Access Compliance Report Public Rights-of-Way (Curb Ramps)

Main Street: STRATTON_WAY		Cross Street: 17TH_ST		Location:	SE
ADA ID: RPRK211007124227	Ramp Type: Type 7 - Directional 2	Initial Pass/Fail: Fail	Overall Compliance: No	Severity Score:	32
Codes/Mitigation Info/Possible Solution			Field Measurements/Component Compliance

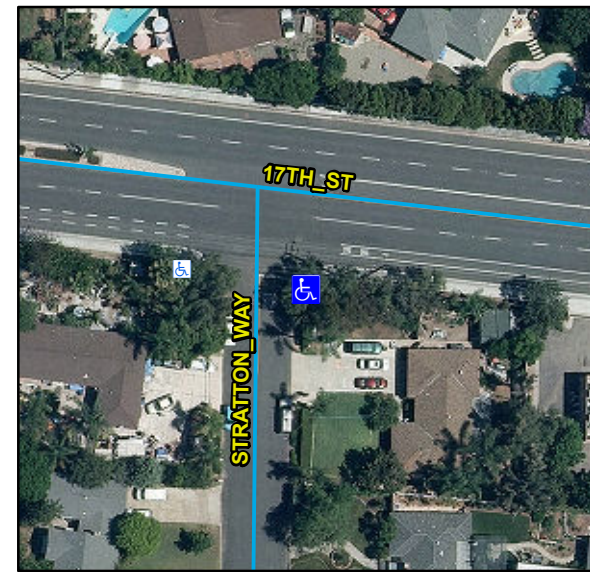
Compliance	Description	Data	Compliance	Description	Data
N/A	Ramp Length (in)	208	N/A	Flare Type LT	
Yes	Ramp Width (in)	75			N/A
Yes	Ramp Run Slope (%)	12.4	N/A	Flare Slope LT (%)	N/A
No	Ramp Cross Slope (%)	2.8	N/A	Flare Traversable LT	N/A
N/A	Grade Break	N/A	N/A	Flare Type RT	
N/A	Grade Break Slope (%)	N/A			N/A
N/A	Grade Break Cross Slope (%)	N/A	N/A	Flare Slope RT (%)	N/A
	Addl Para Ramp Left?	No	N/A	Flare Traversable RT	N/A
	Addl Para Ramp Right?	No	N/A	DWS Provided	N/A
N/A	Landing Present	N/A	N/A	DWS Contrast	N/A
N/A	Landing Length (in)	N/A	N/A	DWS Length (in)	N/A
N/A	Landing Width (in)	N/A	N/A	DWS Full Width	N/A
N/A	Landing Run Slope (%)	N/A		DWS Offset Type	N/A
N/A	Landing Cross Slope (%)	N/A	N/A	DWS Left Offset (in)	N/A
N/A	Landing Movement Obstructed?	N/A	N/A	DWS Right Offset (in)	N/A
	Landing Movement Type	N/A			
N/A	Landing Shared	N/A			
N/A	Marked Crosswalk 1	No	N/A	Clear Space	N/A
	Crossing 1 Direction	W	N/A	Clear Space To Crosswalk (in)	N/A

Marked Crosswalk 1 Width (in)	N/A			
N/A	Ramp Inside Crosswalk 1	N/A			
	Crossing 1 Slope (%)	11.5			
	Crossing 1 Cross Slope (%)	5.9			
N/A	Gutter Ponding	N/A	N/A	Curb Slope	8.1
Yes	Gutter Lip Height (in)	0		Road Run Slope (%)	N/A
N/A	Gutter Run Slope (%)	N/A		Road Cross Slope (%)	N/A
N/A	Gutter Cross Slope (%)	N/A		Parallel Ramp Side	Right
Yes	Overall Surface Condition	Acceptable	Yes	Perp Joint Present	Yes
	Cross Gutter Present?	No		Spandrel Present?	No
	Replace Cross Gutter?	N/A		Replace Spandrel?	N/A

Remove & Replace Entire Ramp.

R304.5.3, STD 1115
